ADDENDUM NO. 06
09 June 2009

Project: **THE NEW TEXAS CITY HIGH SCHOOL**
Texas City Independent School District

Bay Project No.: **0748**

DETAIL AT MARQUEE SIGN

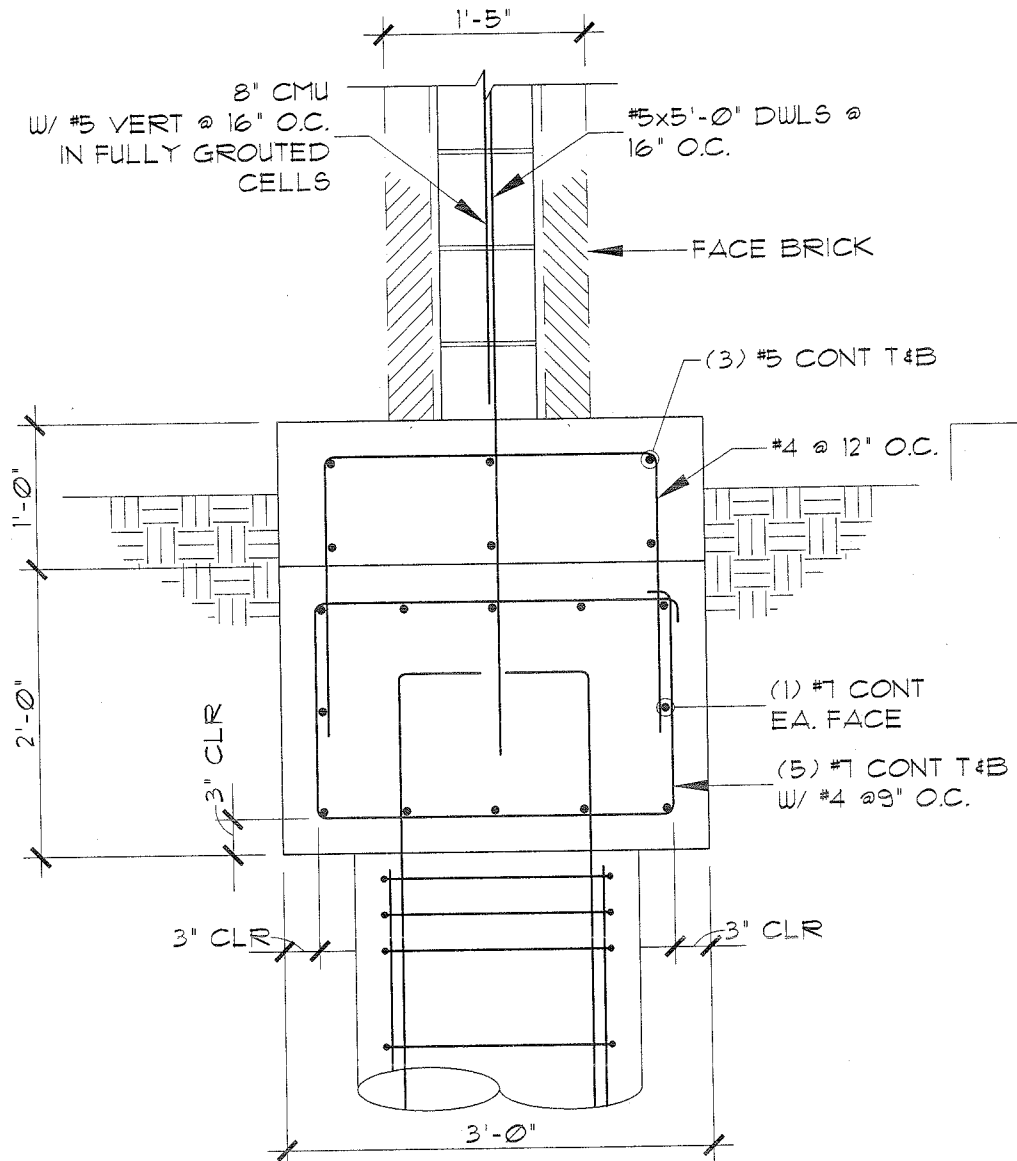
8. Sheet S0.2 Typical Details: Add detail 10/S0.2. See attached **ADD-06-01**.
9. Sheet S0.2 Typical Details: Add detail 11/S0.2. See attached **ADD-06-02**.

**DETAIL AT
MARQUEE SIGN**

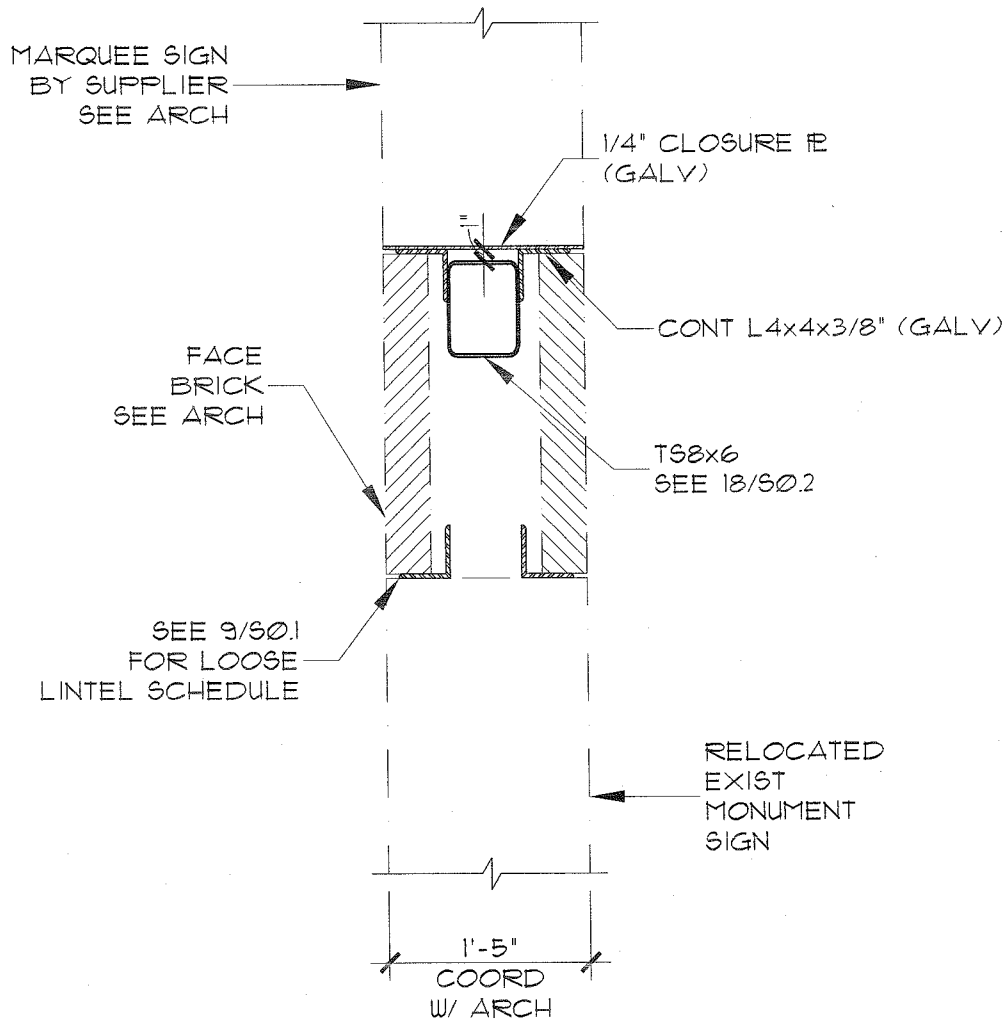
10. Sheet S0.2 Typical Details: Add detail 12/S0.2. See attached **ADD-06-03**.
11. Sheet S0.2 Typical Details: Add detail 17/S0.2. See attached **ADD-06-04**.

MARQUEE SIGN FRAMING ELEVATION

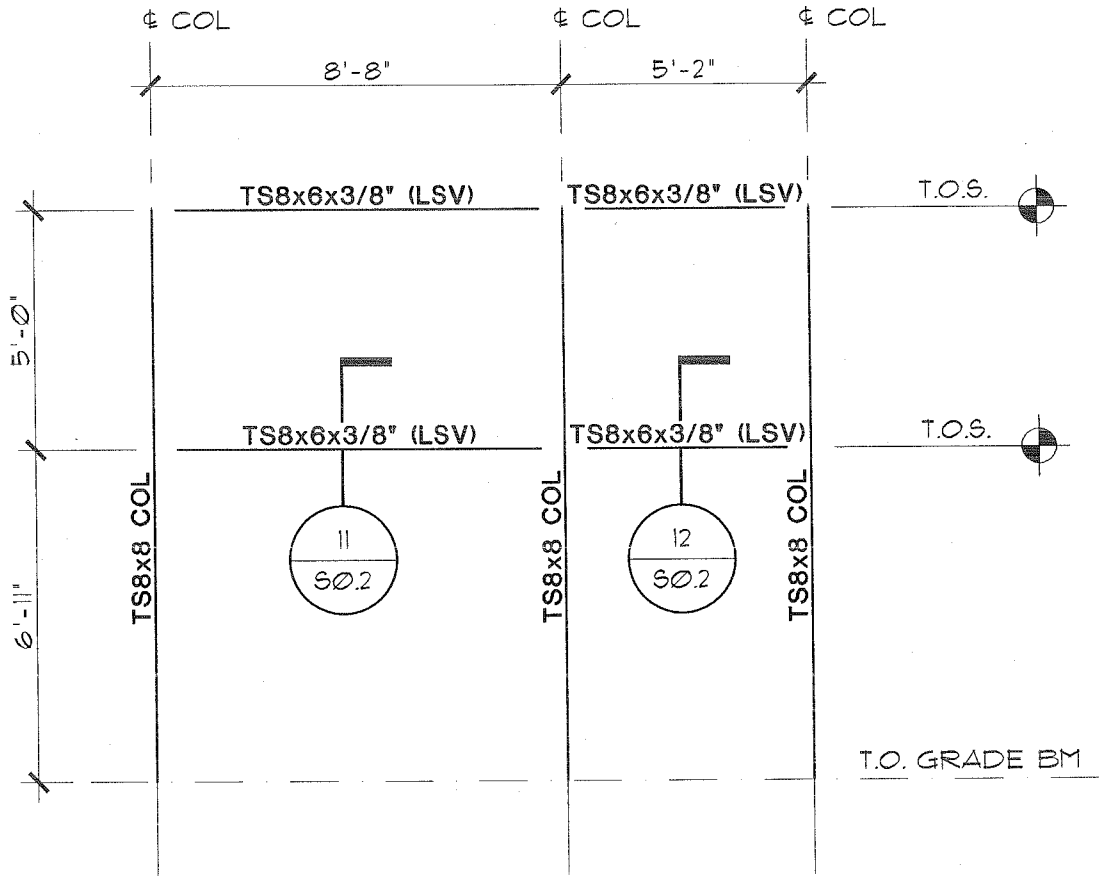
12. Sheet S0.2 Typical Details: Add detail 18/S0.2. See attached **ADD-06-05**.
13. Sheet S1.1 Foundation Plan – Area ‘A’: Add note “Alternate #3 – Provide depression for Terrazzo tile, coordinate location and depth of depressions required with Arch”.
